RE-EVALUATION FORM

A. Re-evaluation Type: Design Change

Project Name: DISTRICTWIDE TAMPA INTERSTATE IMPROVEMENT STUDY

Consultative Design Change Re-evaluation

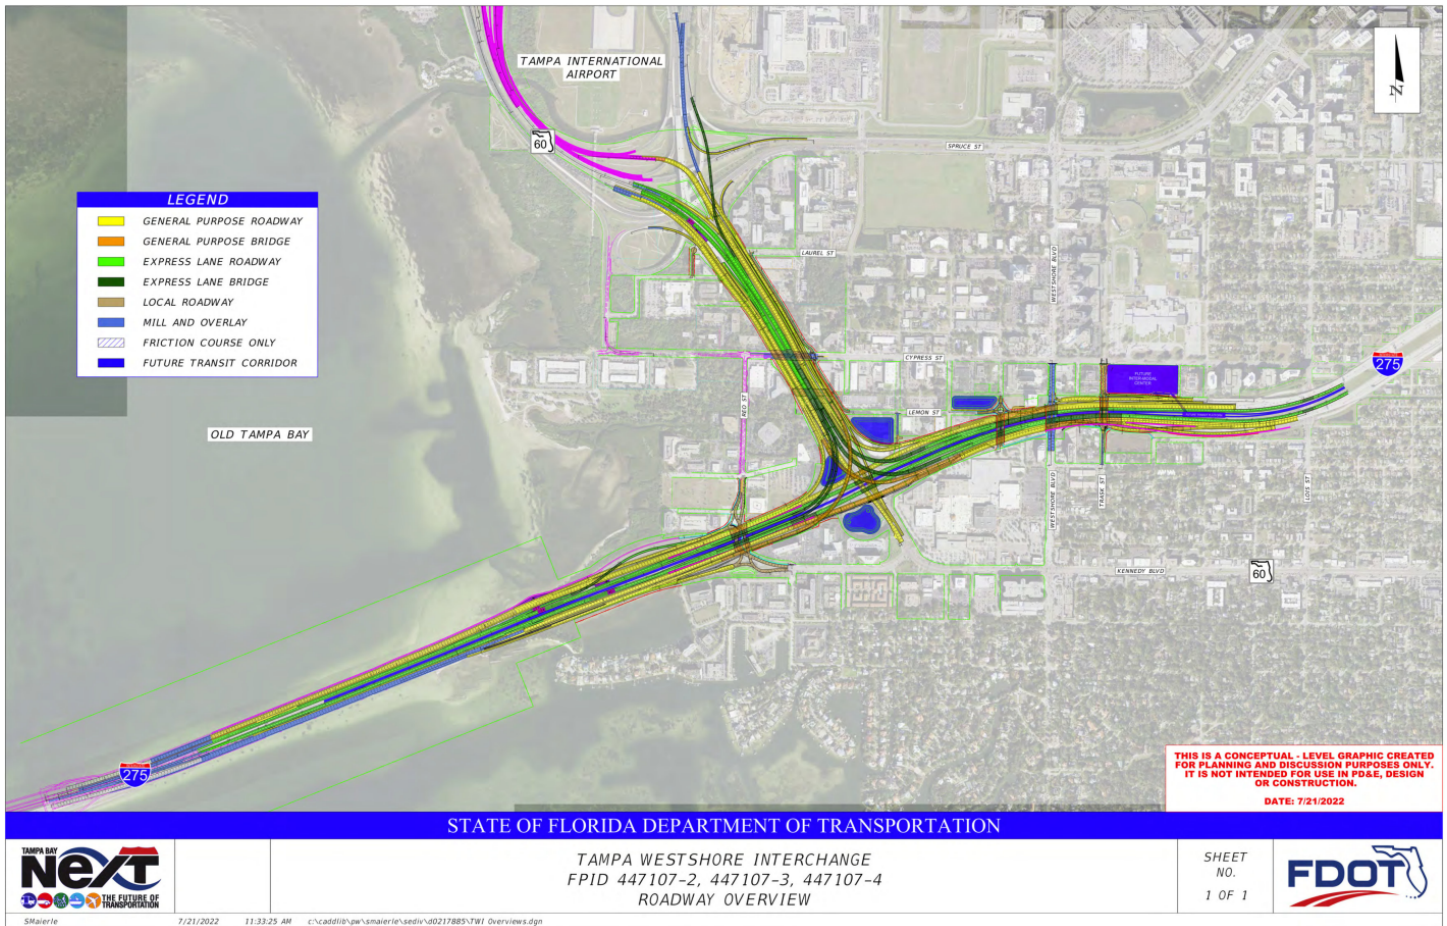
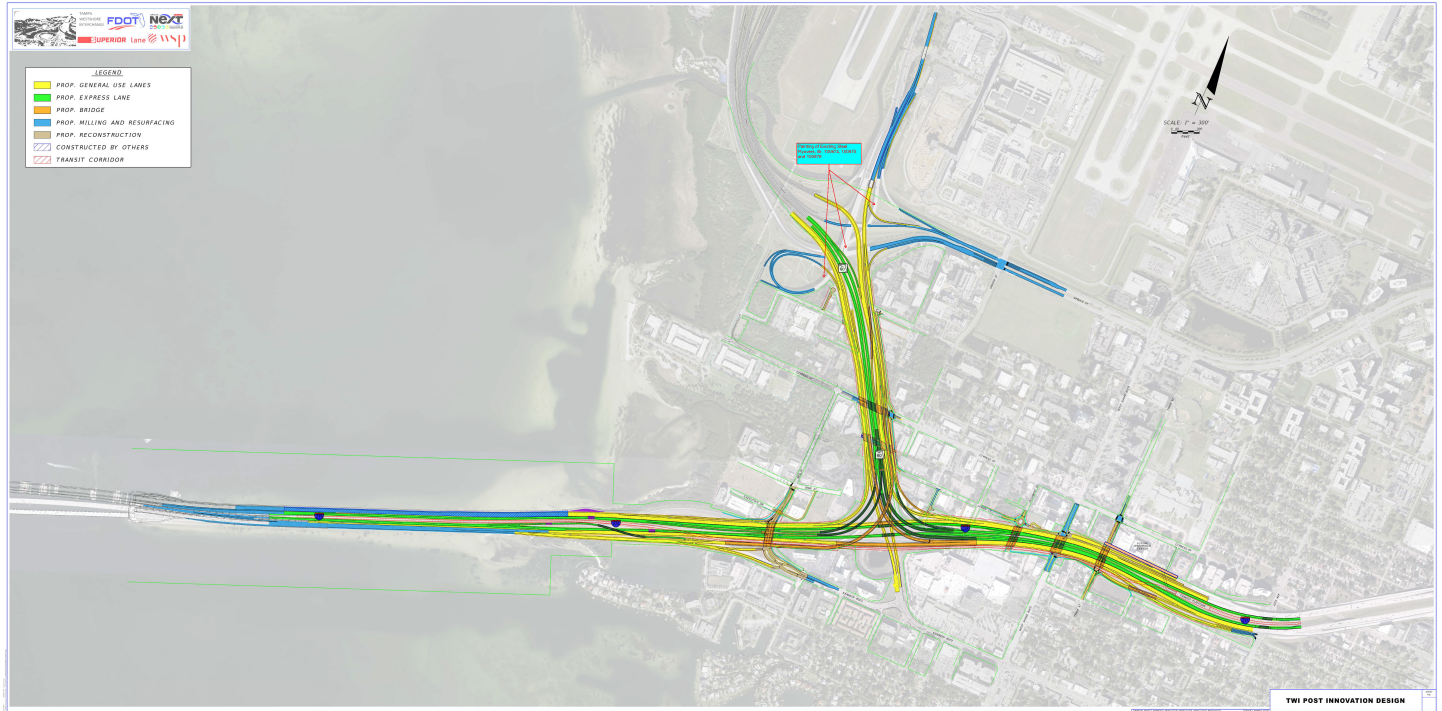
The District plans to relocate the transit corridor from the center of the interstate ROW as depicted in the blue area on the first graphic below to the southern edge of the interstate ROW as depicted in the red hatched area on the second graphic below. This will allow the Westshore Area Interchange (TWI) to be lowered an entire level and potentially provide a future opportunity for a transit station to be placed at a major property that is being redeveloped.
